NOTICE OF DECISION

CLASS 2 MINOR HISTORIC DESIGN REVIEW CASE NO.: HIS23-08

SUMMARY: A proposal to replace windows on the exterior of the Eder House (1918).

Summary: A proposal to replace windows on the exterior of the Eder House (1918).

Location: Basement
West South Wall East End

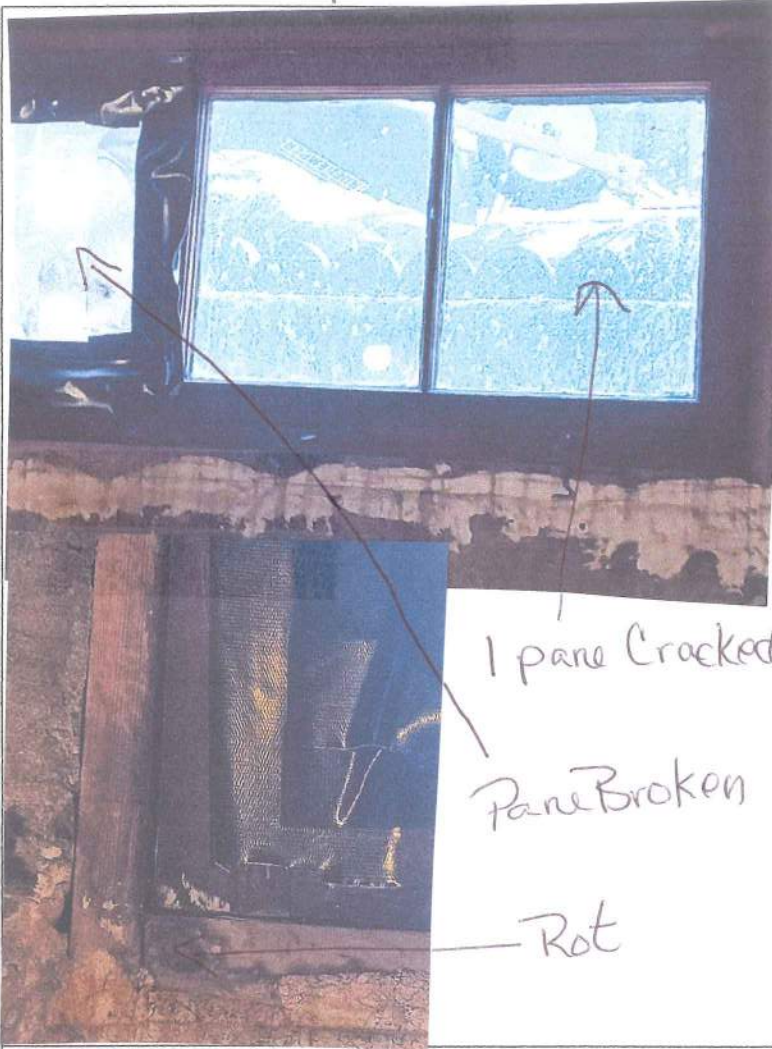
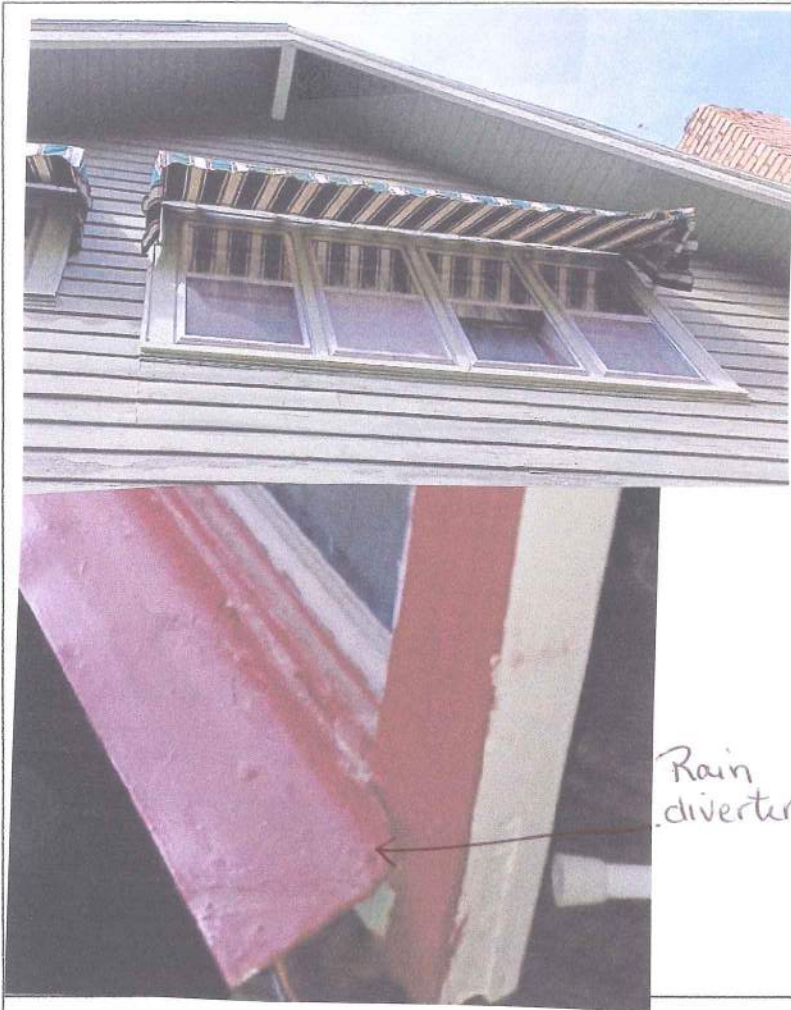
<p style="margin-top: 10px;"> ↑ Cracked ↑ Broken </p>	<p>Location: <u>Basement</u> <u>South Wall East End</u></p>
	<p>Window Description: <u>Wooden Hopper sealed shut.</u> <u>3 single panes</u></p>
	<p>Sill: <u>Poor</u></p> <p> <input type="checkbox"/> Remove paint <input type="checkbox"/> Repair <input checked="" type="checkbox"/> Replace </p>
	<p>Frame/Trim: <u>Poor</u></p> <p> <input type="checkbox"/> Remove paint <input type="checkbox"/> Repair <input checked="" type="checkbox"/> Replace </p>
	<p>Sash/Muntins/Leading: <u>Poor</u></p> <p> <input type="checkbox"/> Remove paint <input type="checkbox"/> Repair <input checked="" type="checkbox"/> Replace </p>
	<p>Glazing Putty: _____</p> <p>% to repair _____</p> <p>% to replace _____</p>
<p>Dimensions of window: <u>Overall - 47.5 x 21.5</u> <u>Frame = 40 x 18.5</u> <u>Panes = 11 x 13</u></p>	<p>Glazing: _____</p> <p> <input checked="" type="checkbox"/> Old <input type="checkbox"/> New <input checked="" type="checkbox"/> Broken </p>

<p>Remarks: <u>Significant water between sill & concrete.</u> <u>Replace with sliding window.</u></p>	<p>Hardware Description: _____</p> <p> <input type="checkbox"/> Remove paint <input type="checkbox"/> Missing </p>

Location: 2nd Story
South bedroom

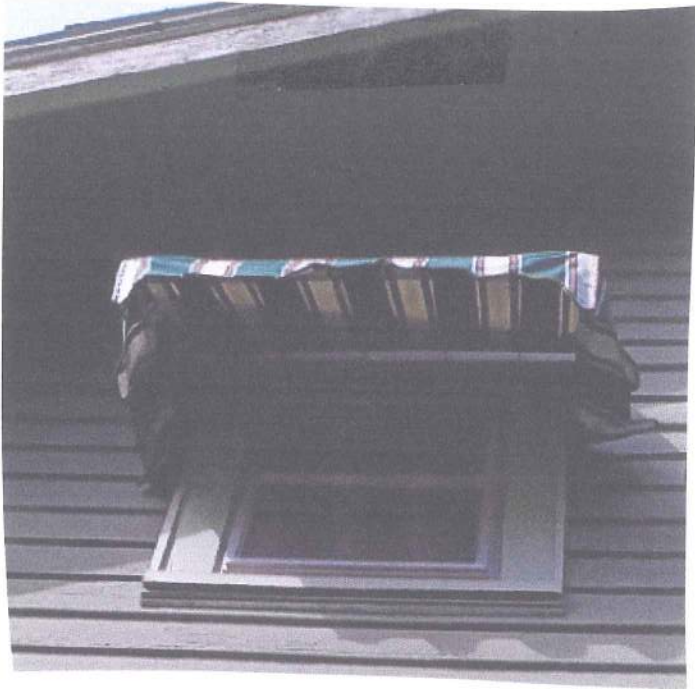
Remarks: 2 center windows are fixed shut. 2 outer ones wont shut, or the wind shakes the hardware until it falls out. water intrusion at some point caused dry rot below the Apron. Awning is rotting & has hole starting

Remarks: 2 outer windows do not latch
shut. Catch pulls out of wood when
windy. 2 inner windows are fixed shut.
water intrusion led to dry rot below Apron.

Location: 2nd story
Bath

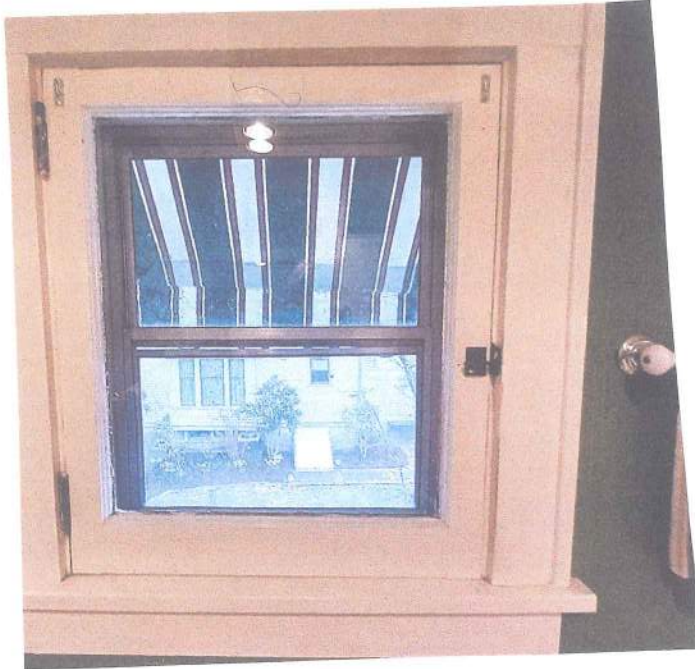
Remarks: would like to replace to be
consistent with age & materials
on this floor

Location: 2nd story
west wall

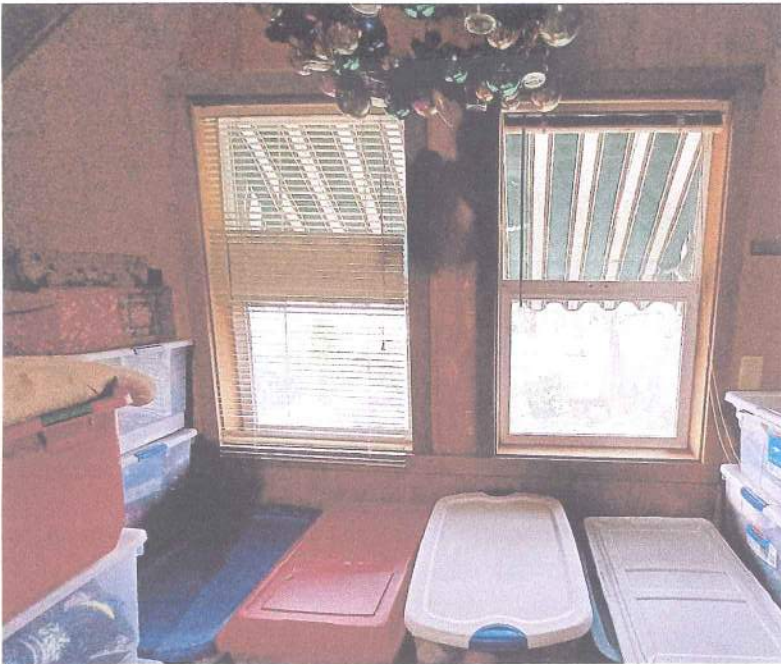
Remarks: Replace to be consistent
with the rest of the house.
Remove Rotting Awning
